MIL-I-6301A
AMENDMENT 2
10 JULY 1981
SUPERSEDING
AMENDMENT 1
18 July 52

MILITARY SPECIFICATION

INDICATOR, PRESSURE, FUEL, 0-600 PSI

This amendment forms a part of Military Specification, MIL-I-6301A, dated 29 February 1952 and is approved for use by all departments and agencies of The Department Of Defense.

FIGURE 1. Dial

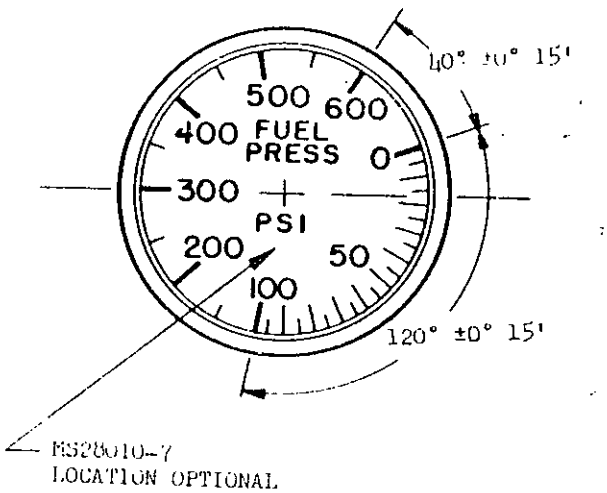
Delete Figure 1 and substitute the figure 1 in this amendment.

3.3.2: Delete "AND 10404-8" and substitute "MS 33585-8".

"3.3.3.1.1 Fluorescent-luminescent markings. The markings shall be finished in fluorescent-luminescent material. The dimensions of the markings shall be as follows:

Height or Length Inch ±1/64	Width of Line or Graduation Inch ±0.005
Numerals 0, 50, 100, 200, 300, 400, 500, and 600	1/8	0.025
Graduation at 0, 50, and each 100	3/16	0.031
Each 10-pound graduation 10 to 90	3/16	0.015
Five-pound graduations and graduations 150, 250, 350, 450, and 550	3/32	0.015
Lettering "FUEL PRESS"	3/32	0.025
Lettering "PSI"	3/32	0.025"
